NOTICE UNDER SECTION 36 OF ACT III OF 1901.

on plot No. 4A

PLAN OF PROPOSED ADDITIONAL STORIES TO BE CONSTRUCTED
ON PORTION OF PLOT NO. 4A, K-2 LYAREE QUARTER
— SCALE 1/8" = 1" —

— GROUND PLAN —

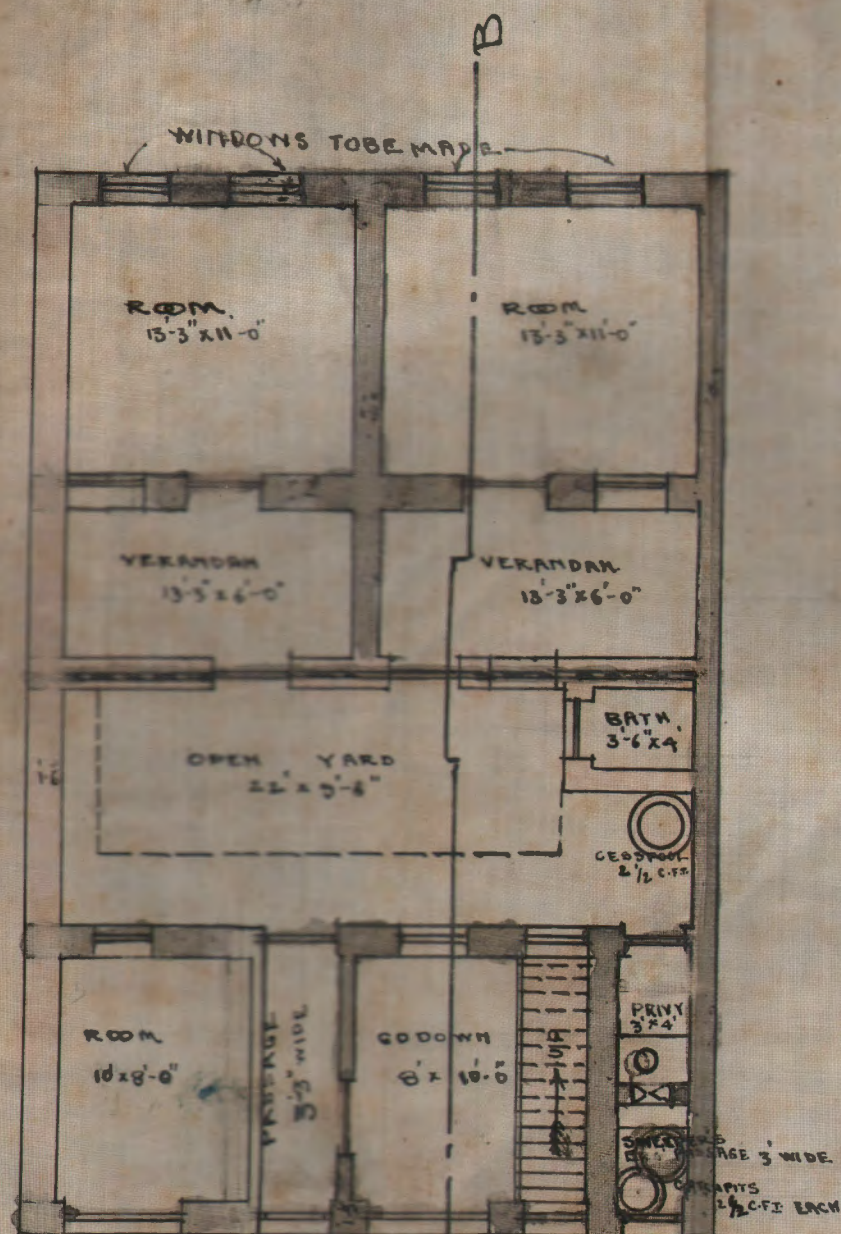
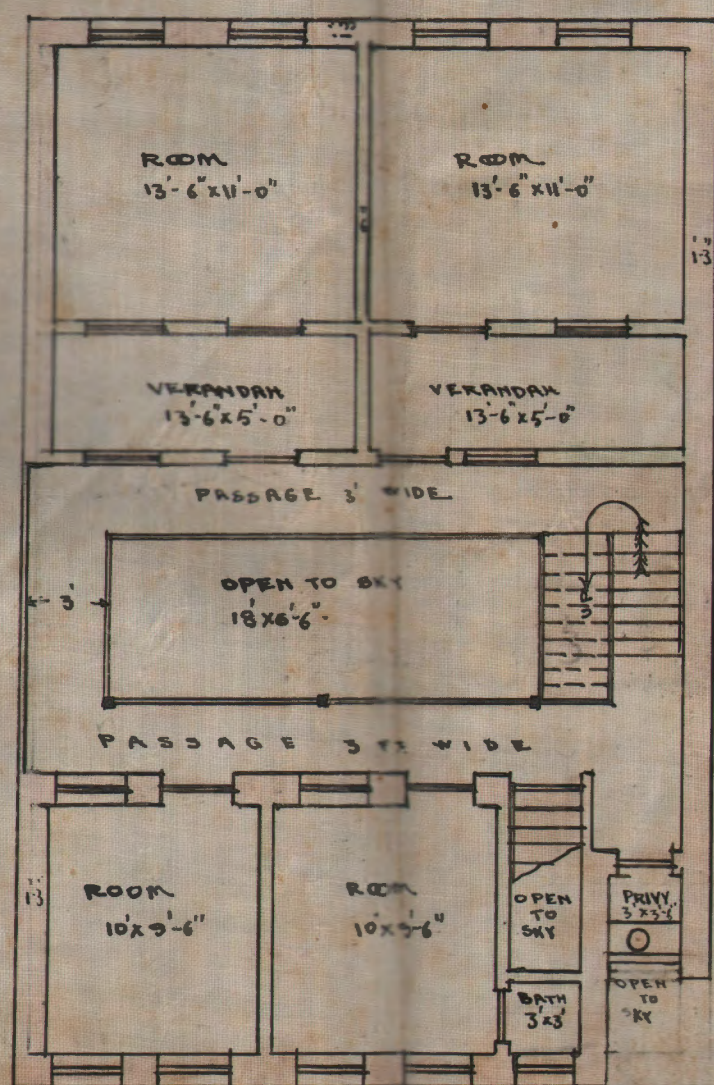
With reference to ~~my~~ application dated 10th November 1916 with plans for building on plot No. 4A, K-2 Lyari Quarter Messrs Narayandas Mohandas and Wakansing. J. are informed that the windows of the rooms to the North of the plot must be increased in size or extra windows put in.

With reference to your letter No E. 10269 of 1916 Dated 23rd ultimo. I beg to send herewith the plans of 4A K-2 Lyaree quarter amended in accordance with your instructions which your honour will kindly approve at your earliest convenience.

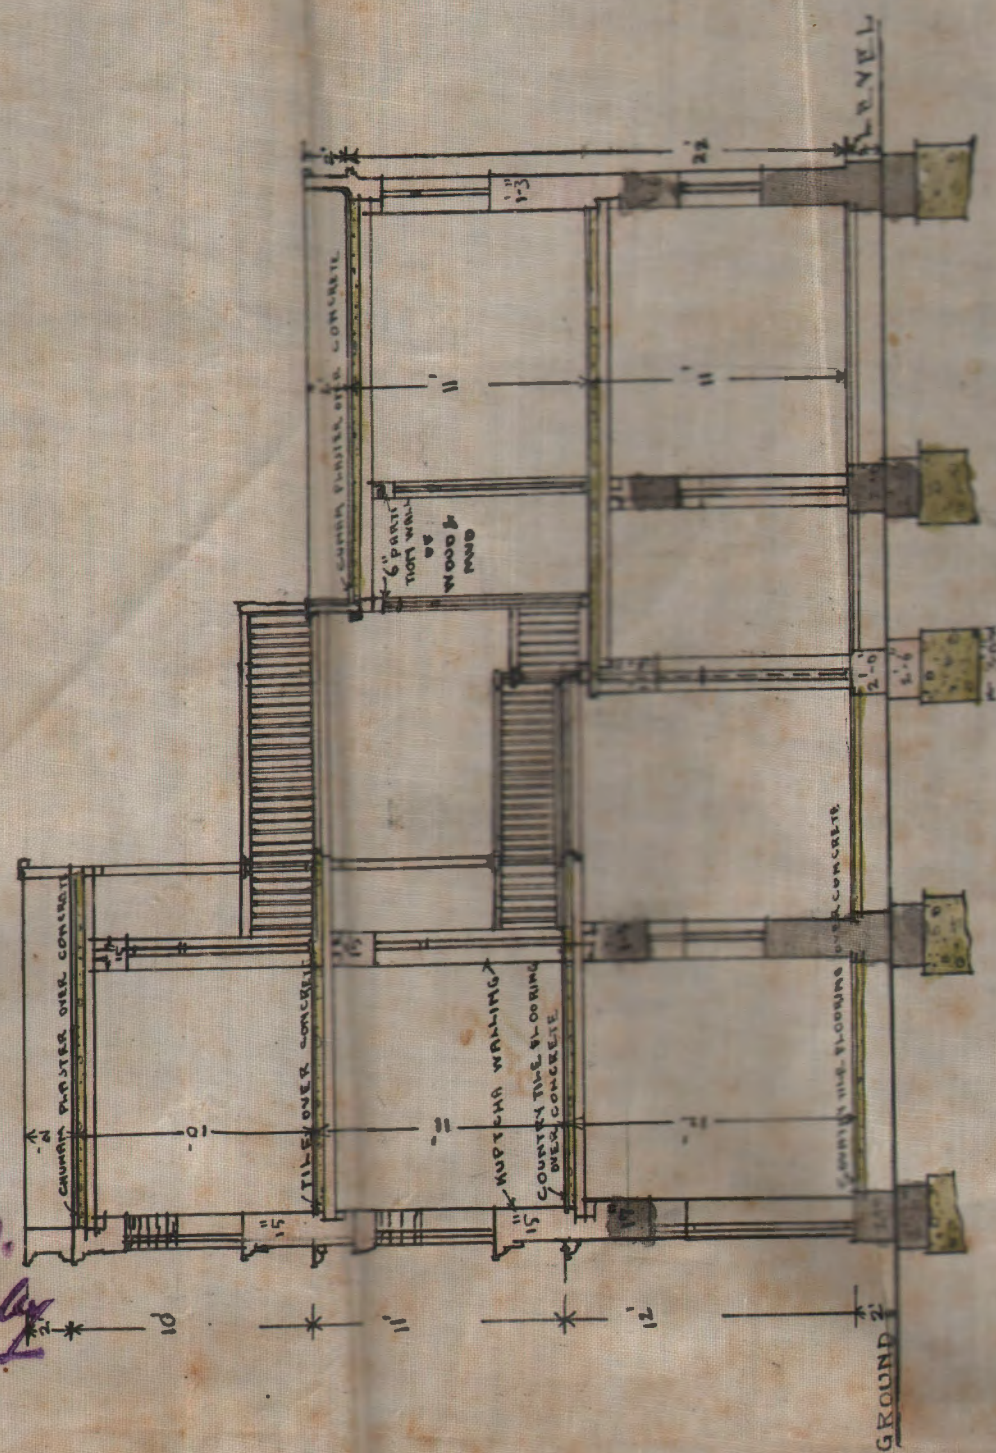
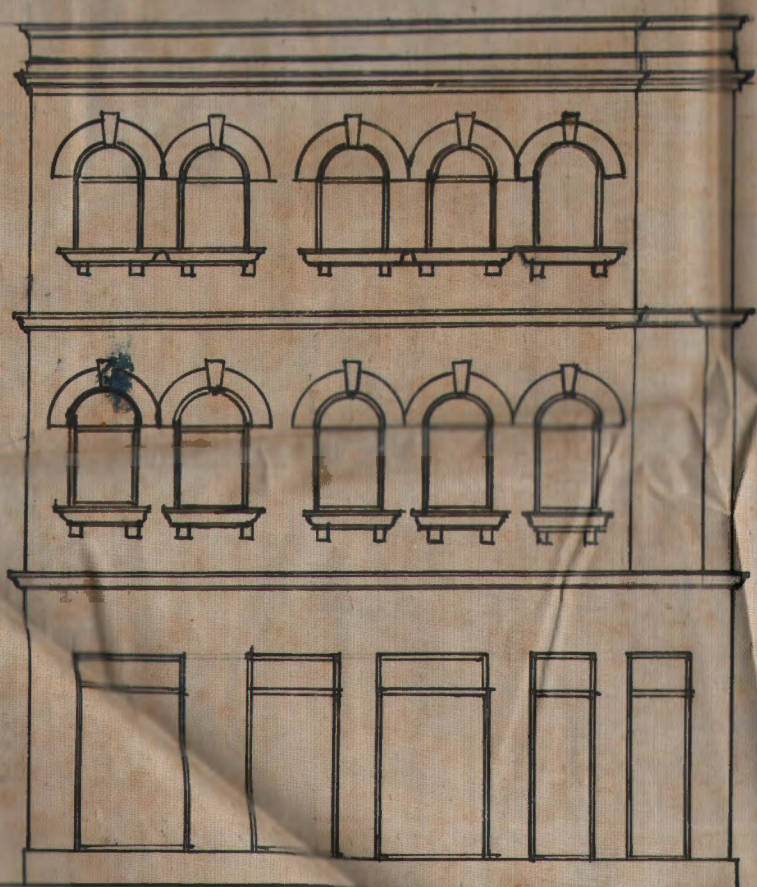
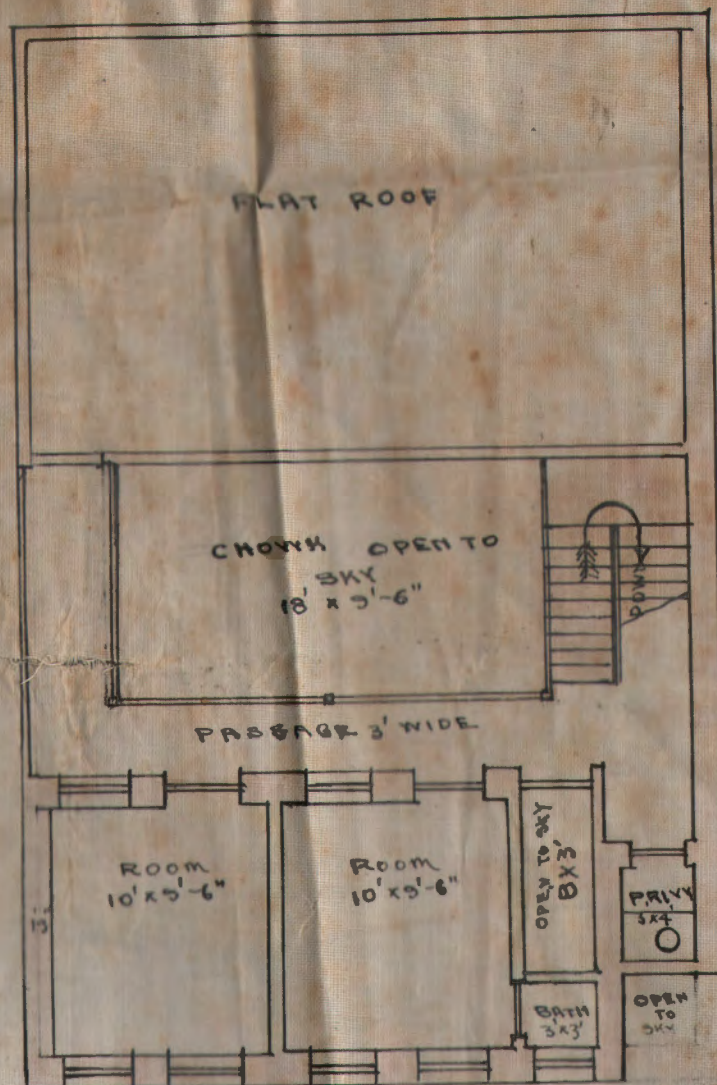
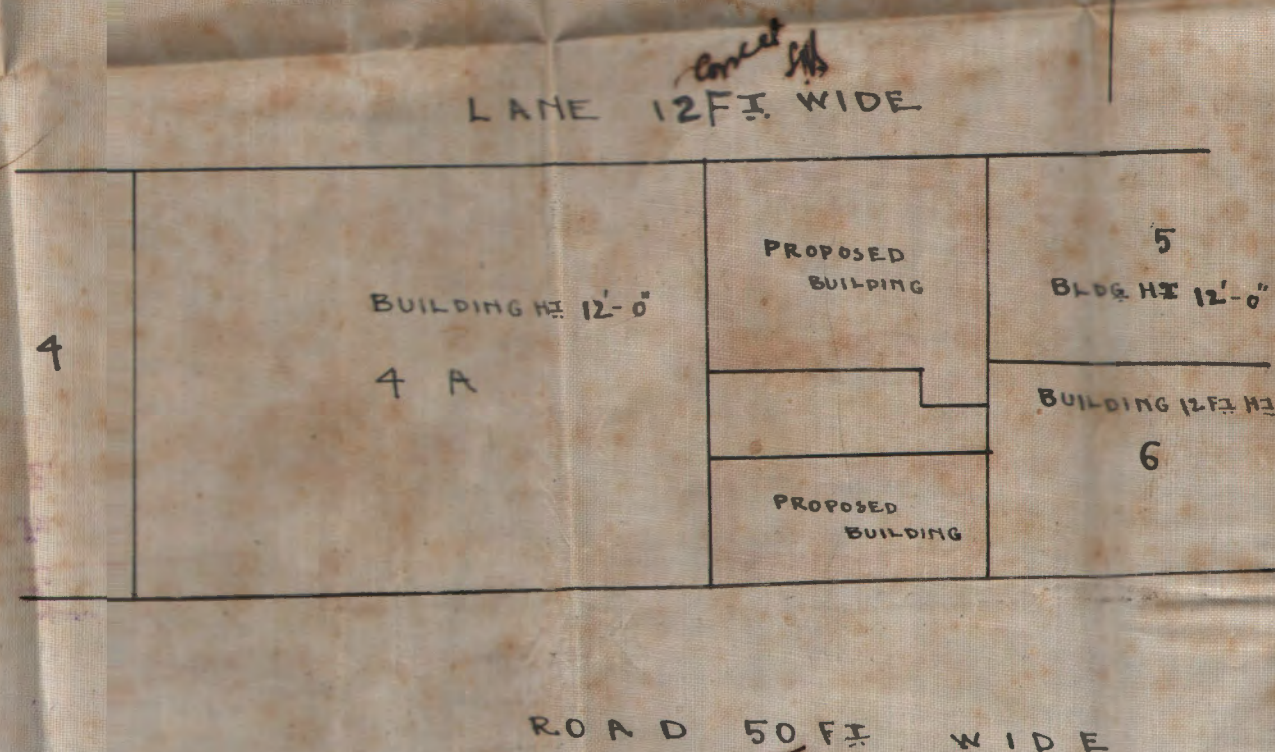
With reference to the attached plans
I beg to report that Plot No. 4 A K2
Lyari Qu. in the Land Register stands
in the name of 6 co-owners - The
applicant wants to bid on a portion
of this plot & thereby subdivide.
This should not be allowed.
Respectfully

With reference to his application dated 6th Oct. with plans Mr: Narayendas Mohandas is informed that the plot No. 4A, K-2 is registered in the name of many occupants and unless the portion proposed to be built upon is officially sub-divided his request can not be considered. The external walls of the building must be made pukka.

With reference to your memo no E9485 Dated 2nd inst I beg to state that I have submitted application for the subdivision of plot no 4 A K.2 Lyaree quarter to the city deputy Collector and it will be duly passed. In the meantime I send my plan for the proposed additions on the portion of plot no 4 A K.2 Lyaree quarter amended in accordance with your instruction which you will kindly approve at your earliest convenience.
